**DOCUMENT 00 90 01  
ADDENDUM #1**

**Project:** 2021-0356

JORDAN VALLEY WATER CONSERVANCY DISTRICT  
**9TH & 85TH WELL PATCH & RE-EQUIPPING**  
MODIFIED WELL DIAGRAM

### Sheet G002

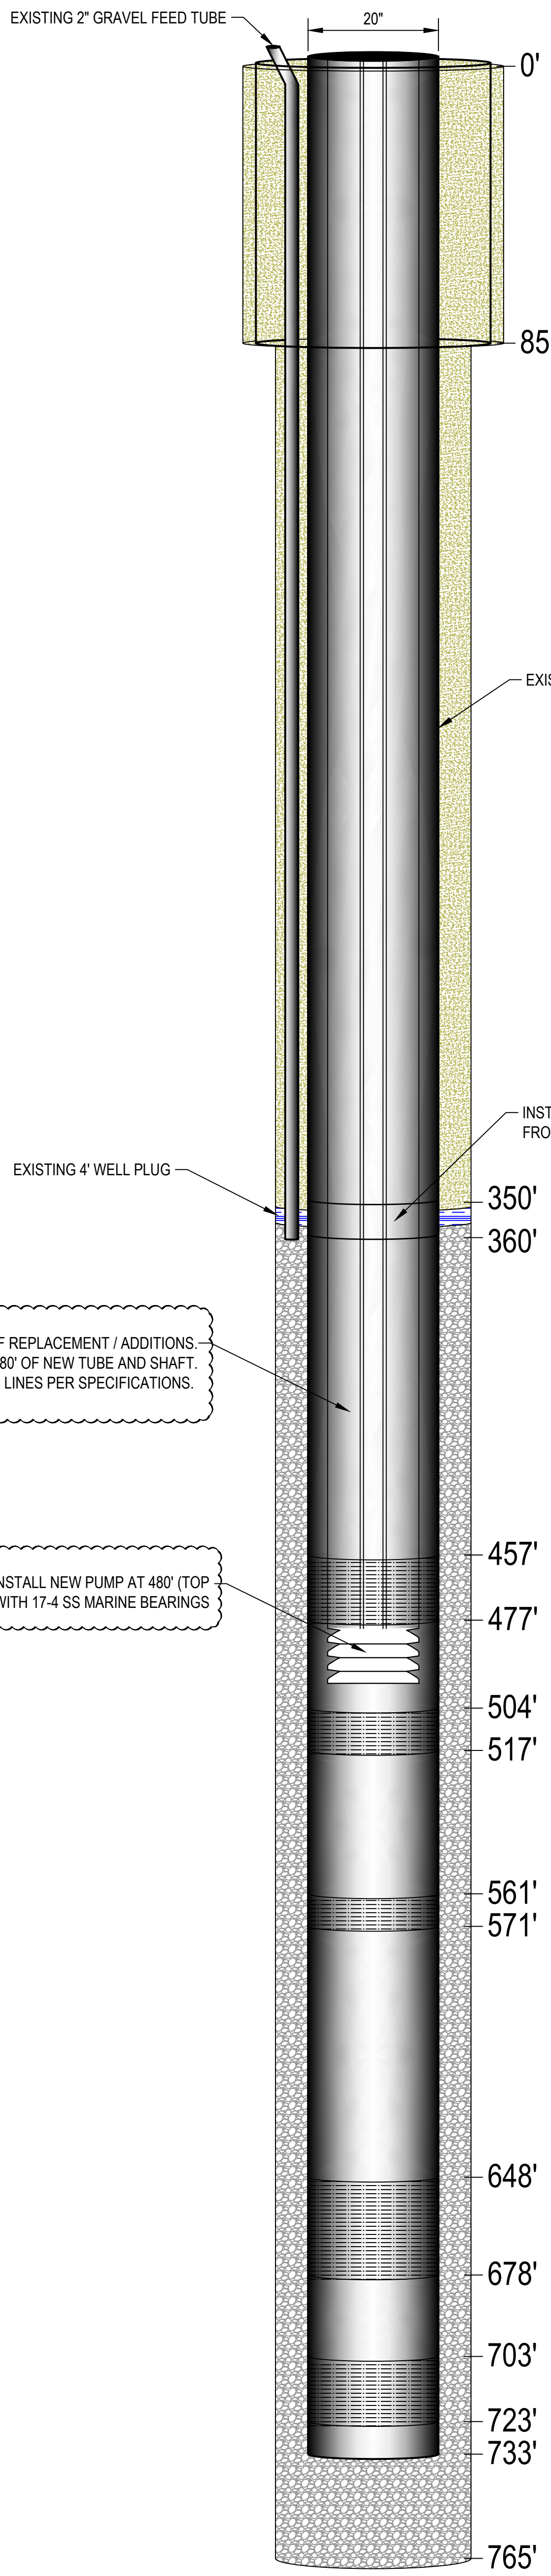
Delete and replace this sheet. A note has been added regarding the reinstallation of the existing tremie lines as well as the change from 316SS marine bearings to 17-4 SS marine bearings and pump shaft.
